SITE PLAN REVIEW AND APPEARANCE BOARD

Rainberry Bay Circle

Meeting	File No.	Application Type
May 22, 2024	2024-011-SPI-SPR-CL1	Level 1 Site Plan Modification with Landscape Waivers
Property Owner	Authorized Agent	
Lois Wiesler, Master Board President	John Haley PE

Consideration of a Level 1 Site Plan Modification for Rainberry Bay Circle including landscape mitigation, replacement of ROW curbs, and a landscape waiver request for LDR Section 4.6.16(H)(6).

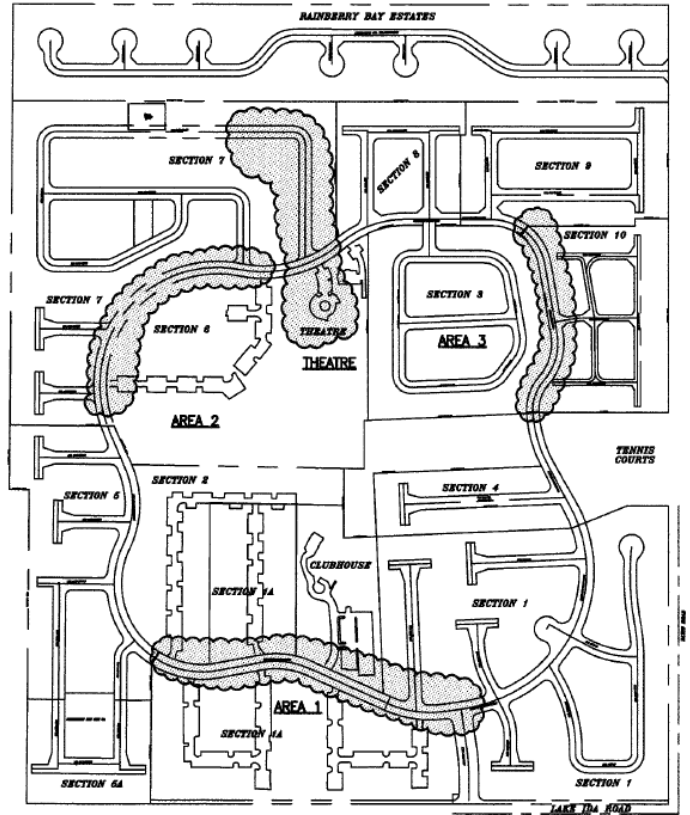
The proposed modification is limited to the mitigation of removed trees, and the replacement of curbs to Type "D" curbs for the recently re-paved ROW (Rainberry Circle). The areas clouded to the right are the areas the mitigated trees are proposed.

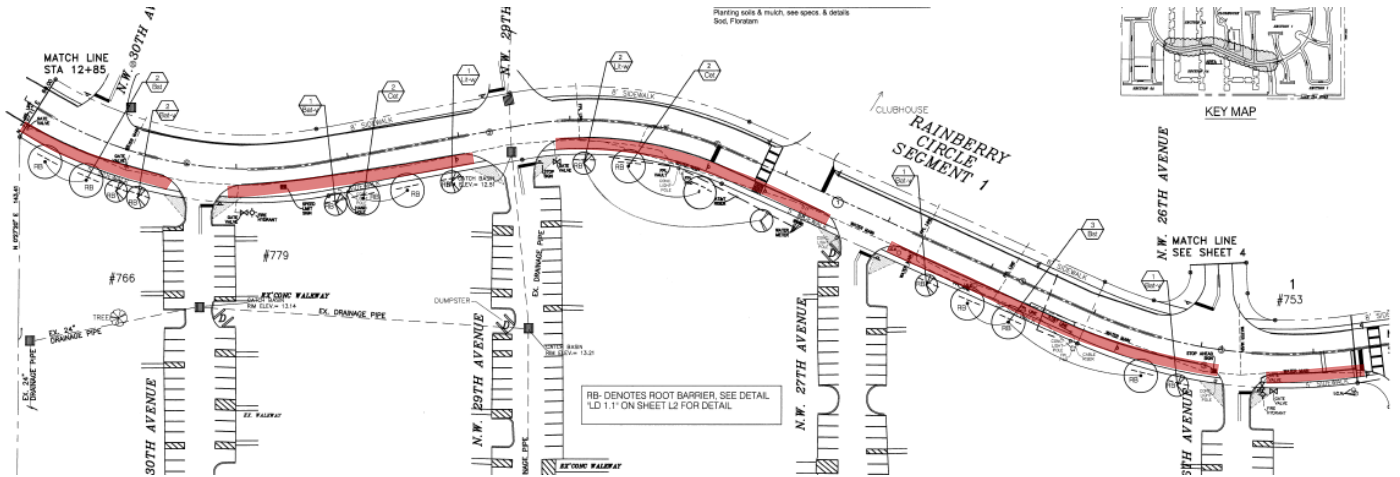
Pursuant to LDR Section 4.6.16(H)(6), street trees are required to be located between the inside edge of sidewalk and edge of road pavement (highlighted in red). If the trees were to be placed in the required location per LDR Section 4.6.16(H)(6), the trees would not comply with the AASHTO Green Book standards; the distance from edge of travel lane to any hazardous vehicle obstruction such as a tree for roadways with speed 35 to 45 mph, is 14 feet minimum. There is also an existing watermain and other utilities (AT&T, FP&L and cable TV) conflict with the required location of the street trees. The request is to locate the trees on the outside of the sidewalk adjacent to Rainberry Circle (North, South, and East).

Overall, the request is not anticipated to negatively affect the area or create an unsafe situation. The request will still be providing the required street trees, however, due to the Green Book standards and the conflicting utility lines, the trees cannot be placed in the required location without creating a hazardous situation and damaging existing utilities.
